RESOLUTION NO. R-4377

A RESOLUTION OF THE CITY COUNCIL OF THE CITY OF KIRKLAND ADOPTING A MASTER PLAN FOR WAVERLY PARK.

# Waverly Park Master Plan

**Subject:** WAVERLY PARK MASTER PLAN, Analysis of compliance with Comprehensive Plan, Development Regulations, and Environmental Record

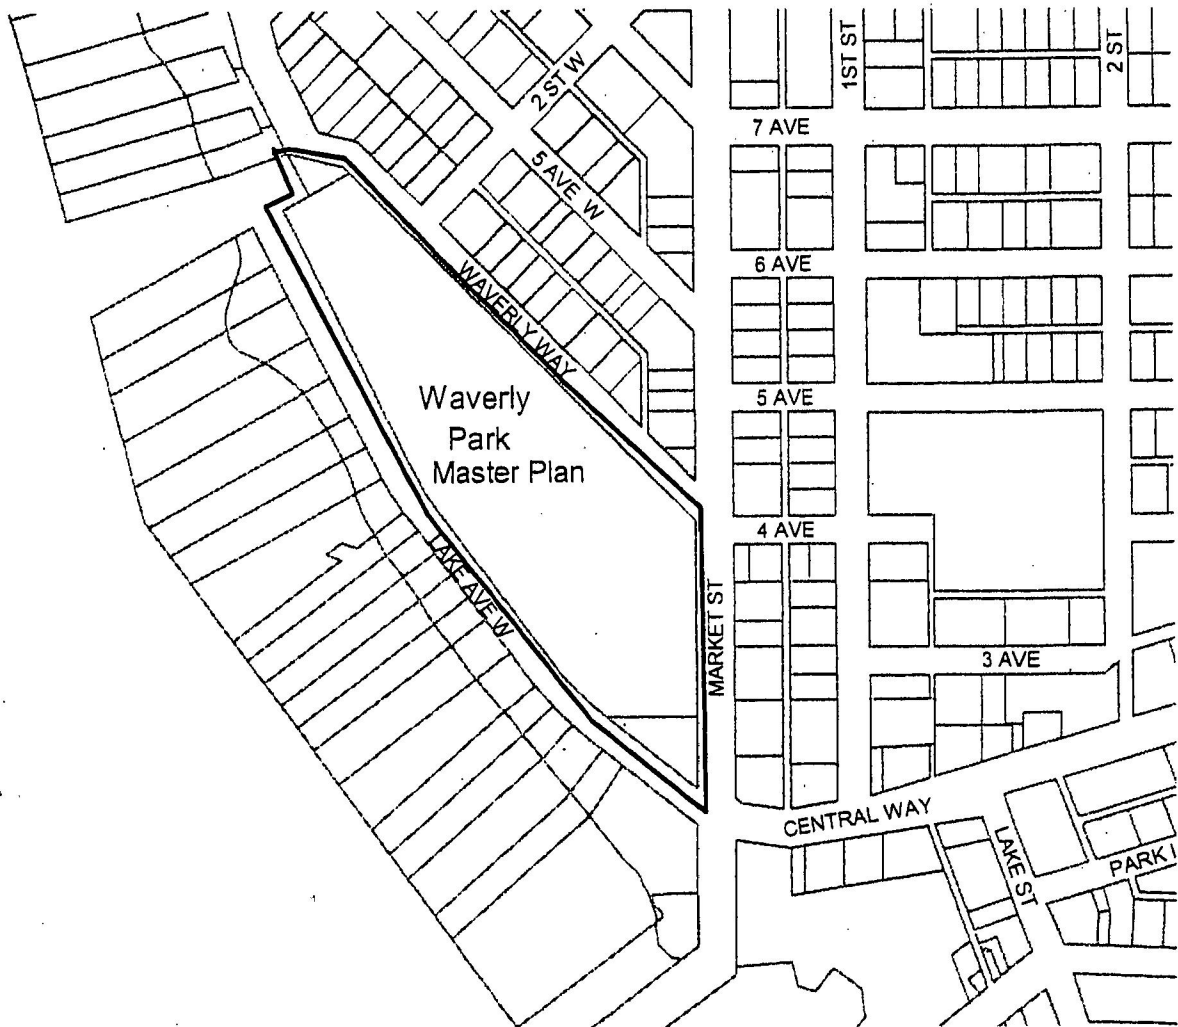
The proposal shows elimination of the existing bike lane along the west side of Waverly Way and replacement with a bike lane trail traveling through the park.

8. Conclusion: The pathway through the park will retain needed pedestrian and bicycle connections and meets the intent of the Comprehensive Plan.

# Waverly Park Schematic Plan

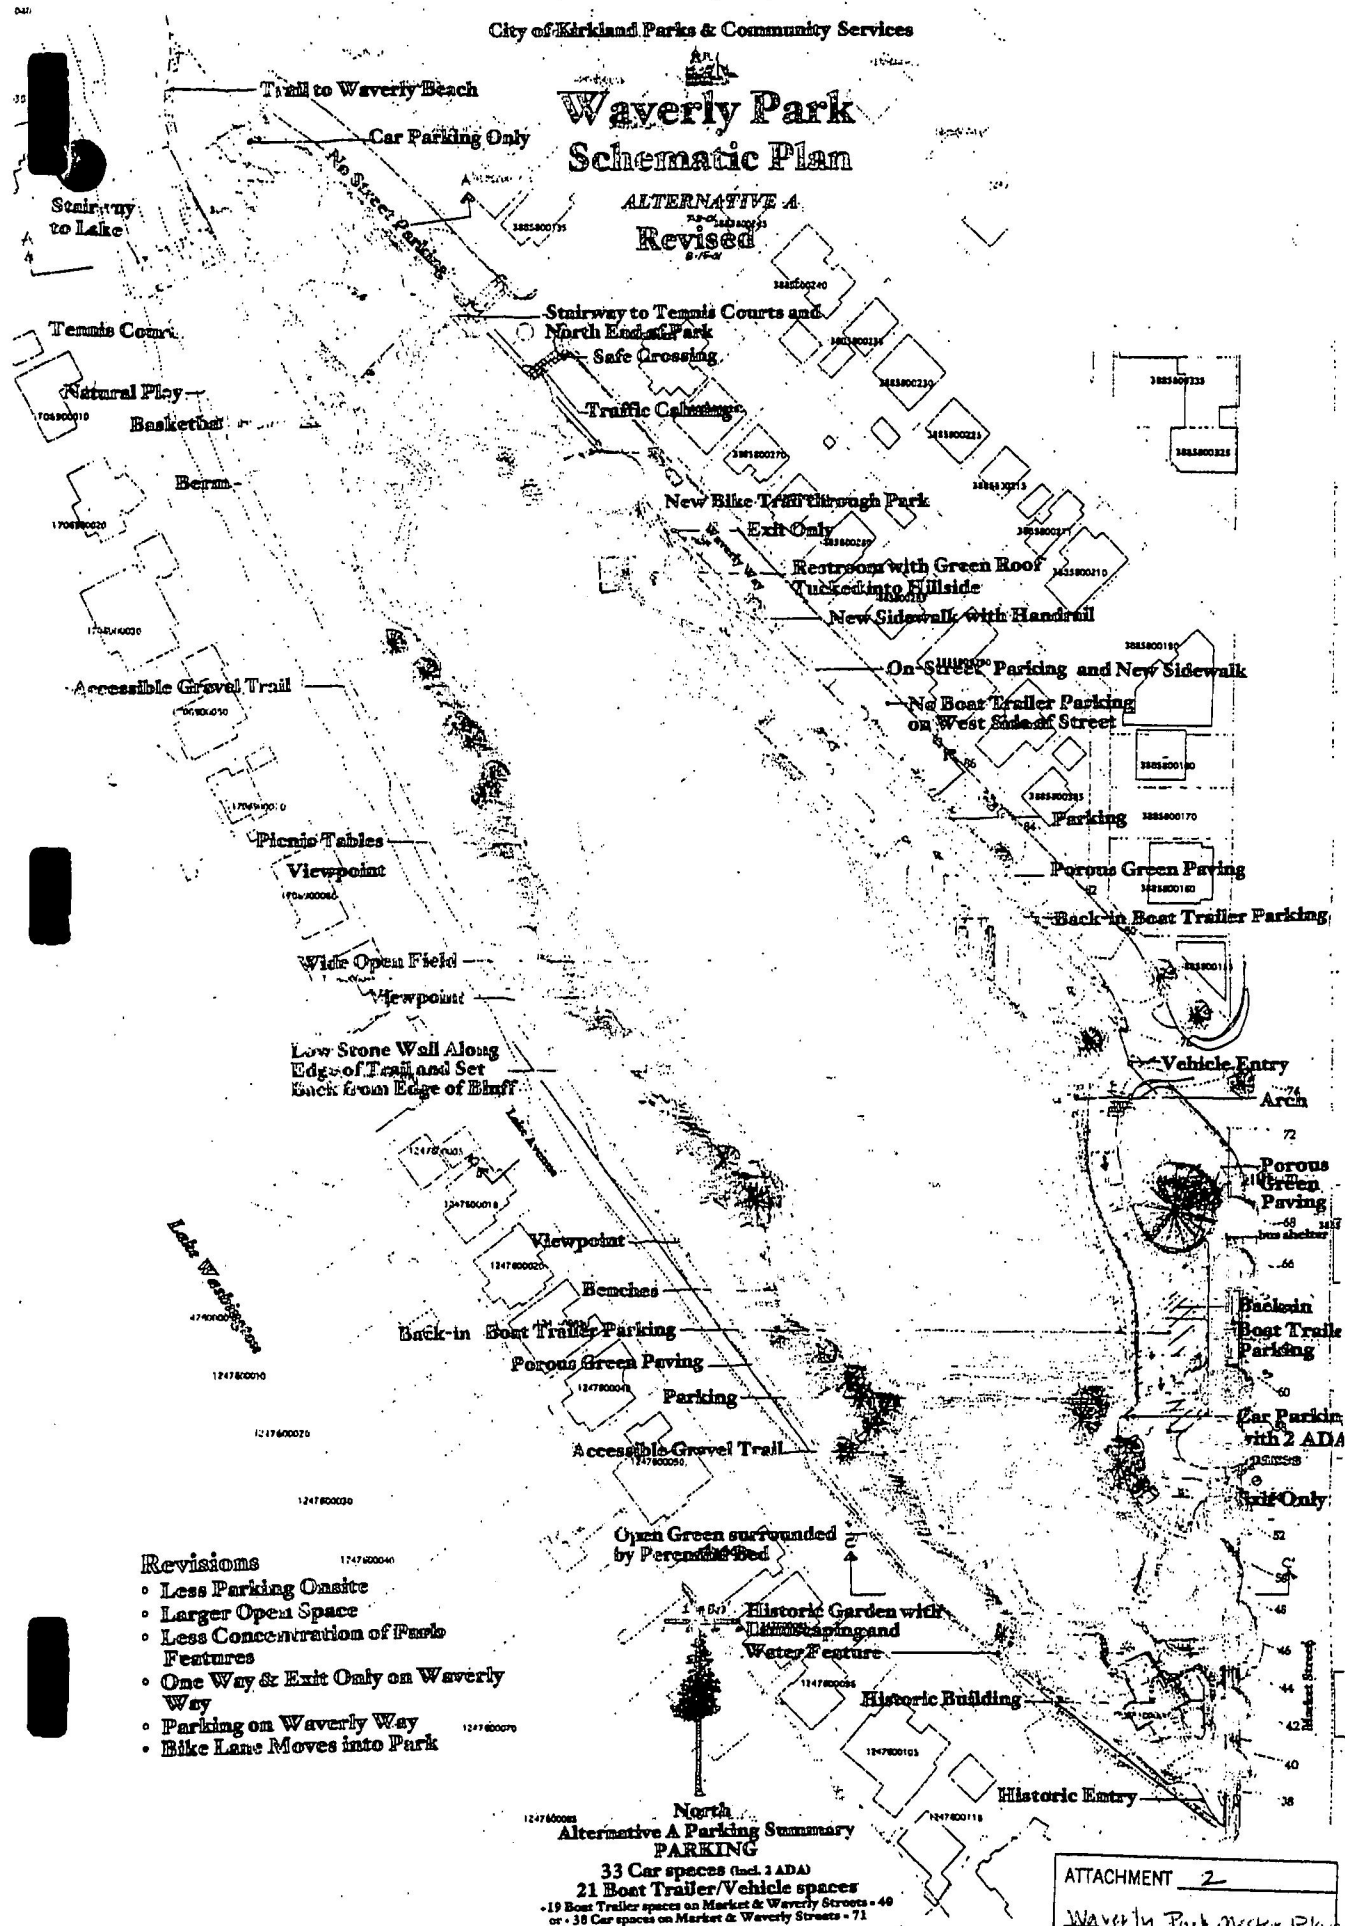
*Staff Analysis: Covered bicycle parking should be provided within 50 feet of the entrance to Heritage Hall. No bicycle parking facilities are currently shown on the site plan.*

*Staff analysis: The design plans for the restroom facility shall include overhead weather protection along the portion of the restroom that adjoins the pedestrian walkway.*

In the proposed parking plan, there are some rows that contain more than eight contiguous spaces.

- a. Covered bicycle parking should be provided within 50 feet of the entrance to Heritage Hall.
- b. The design plans for the restroom facility shall include overhead weather protection along the portion of the restroom that adjoins the pedestrian walkway.

1. The proposed final parking design is consistent with the requirements for parking lots established in Chapter 105 with the following revisions:
  - a. The parking lot should be designed consistent with the standards outlined in Attachment 3.
  - b. The parking lot should be revised so that no more than 8 contiguous spaces are provided in each row of spaces, unless a modification to the parking lot landscaping is granted subject to compliance with the criteria set forth in KZC 105.103.e.

- c. The parking lot should be surfaced with asphalt or superior material. In order for the porous green paving to be used, it must be found consistent with the criteria set forth in KZC 105.103.h.
- d. The temporary use of the existing gravel parking lots is consistent with the modification criteria established in KZC 105.103.h and should be permitted until such time as funding sources for the development of the remaining portions of the public park become available, provided that appropriate periodic maintenance of the parking lots is completed (e.g. removal of potholes).
